MINERALS PROGRAM INSPECTION REPORT
PHONE: (303) 866-3567

MINE NAME: North River Gravel Pit Extension	MINE/PROSPECTING ID#: M-1999-007	MINERAL: Gravel	COUNTY: Rio Blanco
INSPECTION TYPE: Surety Release Inspection	WEATHER: Clear	INSP. DATE: July 24, 2023	INSP. TIME: 12:30
OPERATOR: George T. Weldon Construction, LLC	OPERATOR REPRESENTATIVE: None	TYPE OF OPERATION: 110c - Construction Limited Impact	
REASON FOR INSPECTION: Surety Release Requested	BOND CALCULATION TYPE: None	BOND AMOUNT: \$11,750.00	
DATE OF COMPLAINT: NA	POST INSP. CONTACTS: None	JOINT INSP. AGENCY: None	
INSPECTOR(S): Amy Yeldell	INSPECTOR'S SIGNATURE: 	SIGNATURE DATE: August 10, 2023

Photo 2: Access road to Area 2 and 3

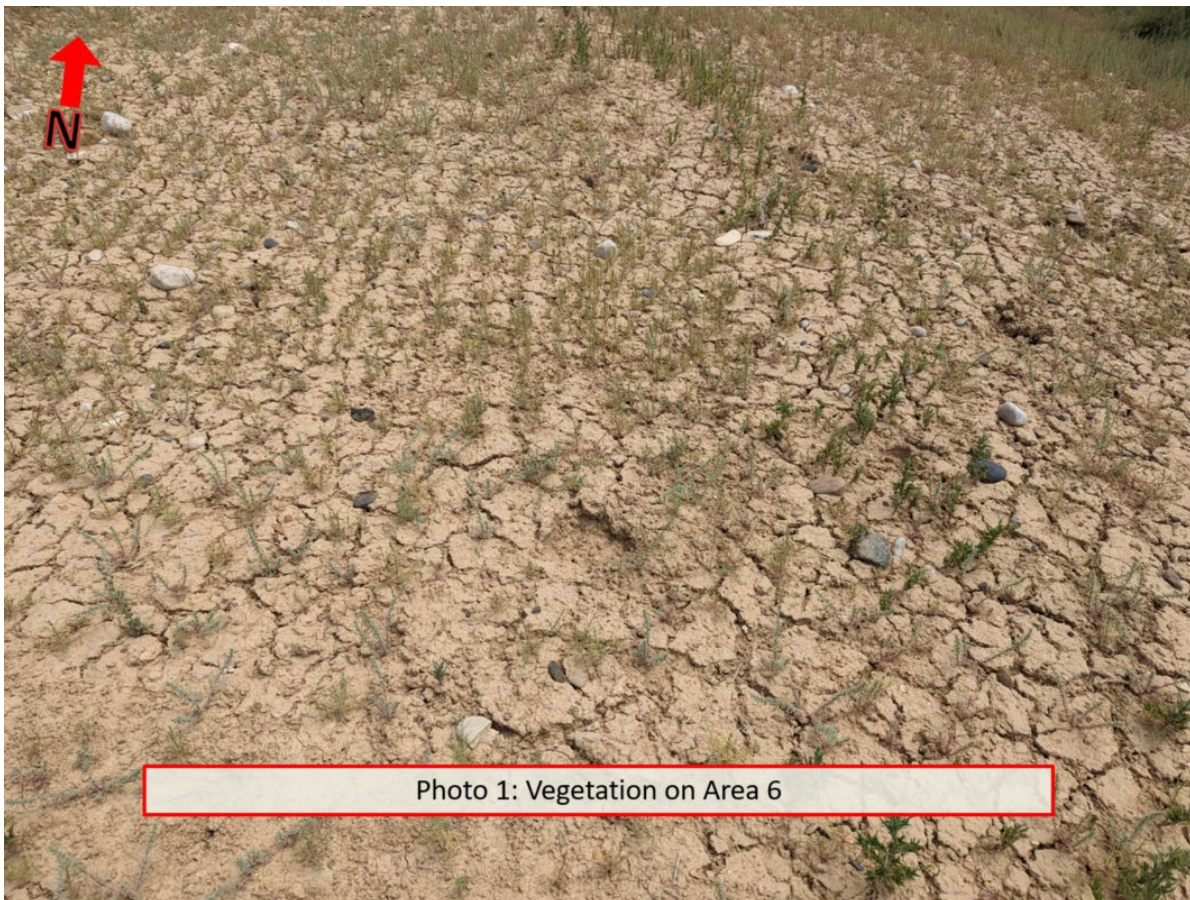
The access road to area 2 and 3 remains flat for future use but overall is well vegetated. Species are diverse and

generally weed free with some Kochia (See Photo Two). Little to no erosion was observed. Cover/density is comparable to undisturbed adjacent areas. It is noted on the northeast side of Area A adjacent to the access road several tires and other trash from historical use was observed.

Photo 3: Area A looking towards new reclaimed areas

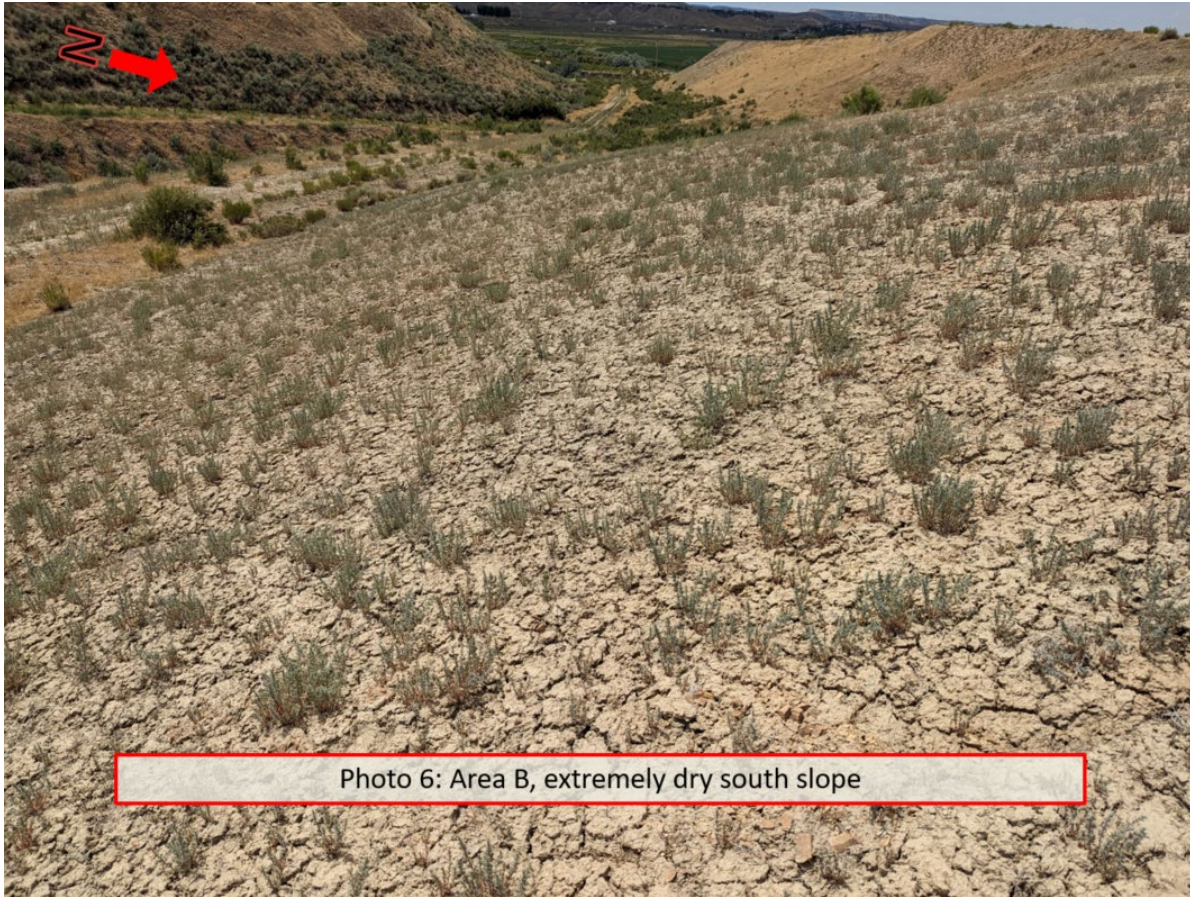
Area A did not require any sort of grading for final reclamation and has had volunteer shrubs (rabbit brush and saltbush) due to it being deserted. Only the southwestern portion of Areas A appear to have additional seeding. Cover is comprised of mostly desirable forbs (annual flowers) and shrubs. The recently reclaimed southwestern area has a lower density of desirable cover (See Photo Three). The rocky more open areas have significantly higher densities of cheatgrass and Russian Thistle.

Photo 9: Cracks in Area 4.

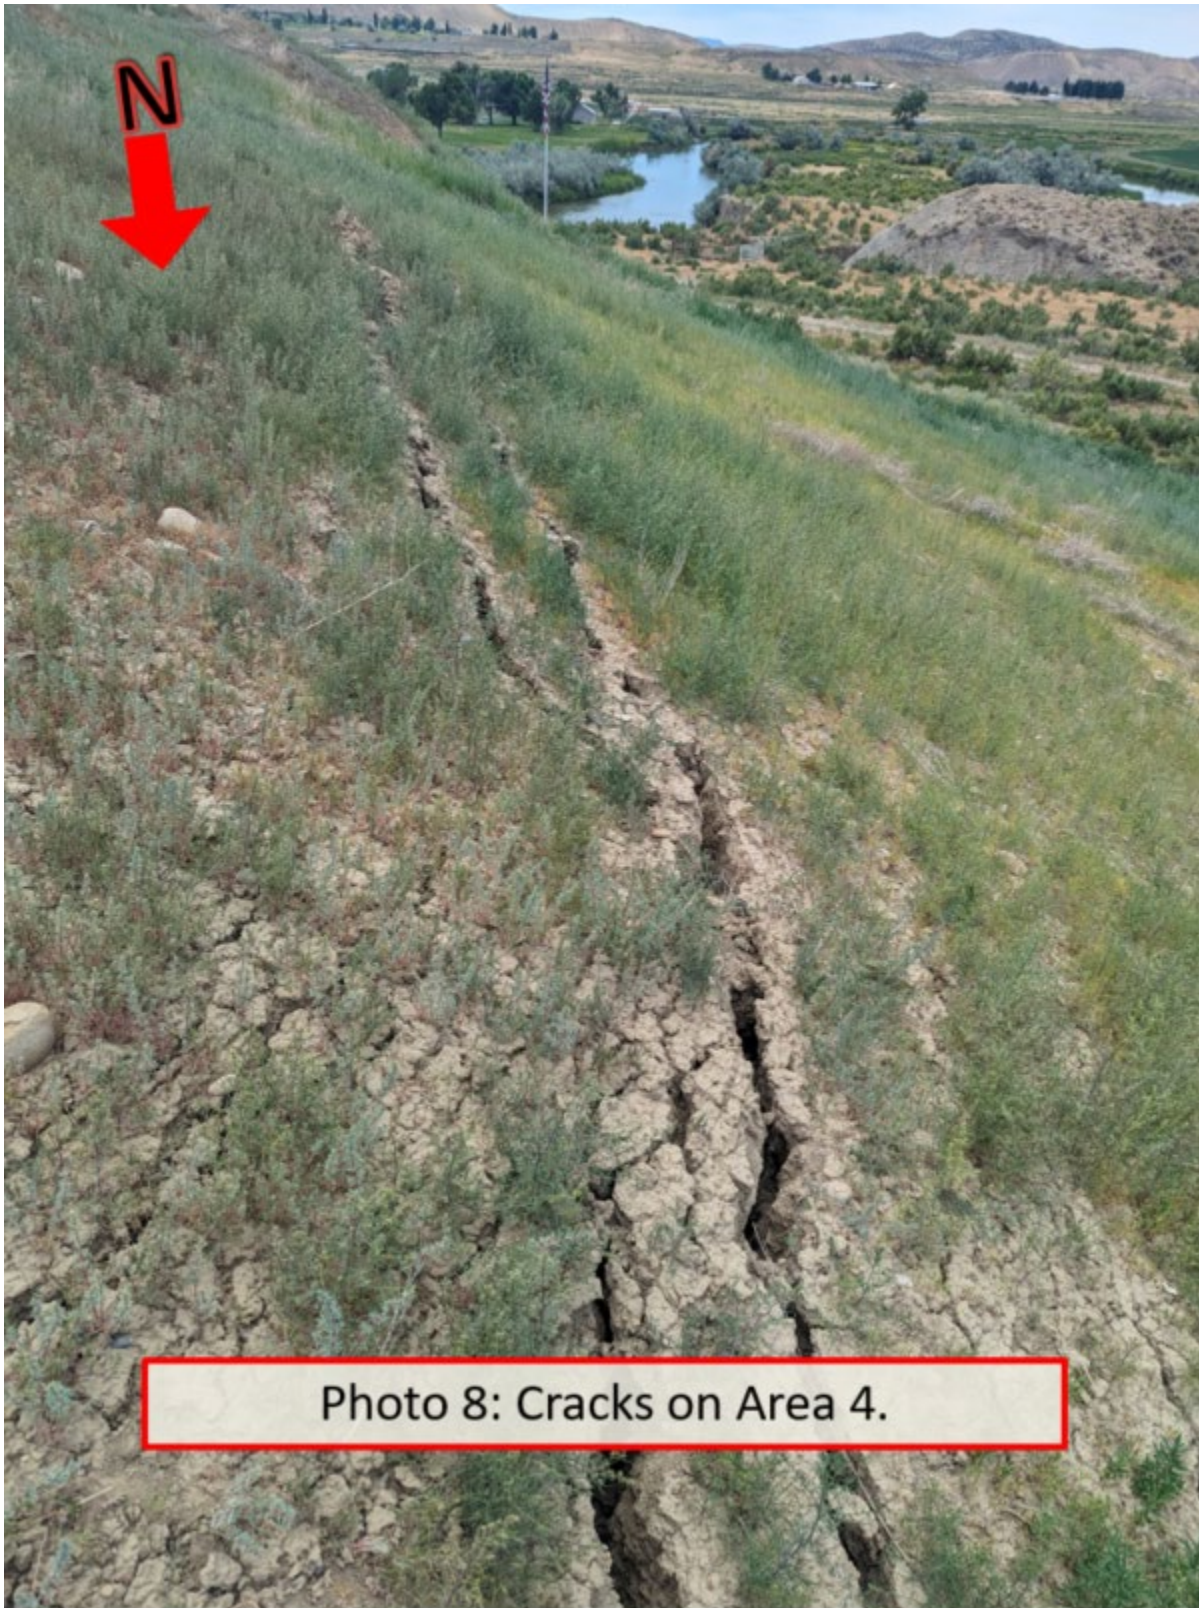
The western slope of area 4 has a stress crack (See Photo Eight and Nine). This slope will need to be repaired (graded) and reseeded. Given that sufficient material is on site a more gradual slope that is sufficiently compacted may resist settling better. The interstitial grade adjacent to the crack appears to be steeper than a 3H: 1V though the overall grade is a 3H: 1V. The crack is perpendicular to the slope and runs nearly the entire length of the slope. Smaller less apparent cracks were observed below the main one. This area will need to be repaired and reseeded.
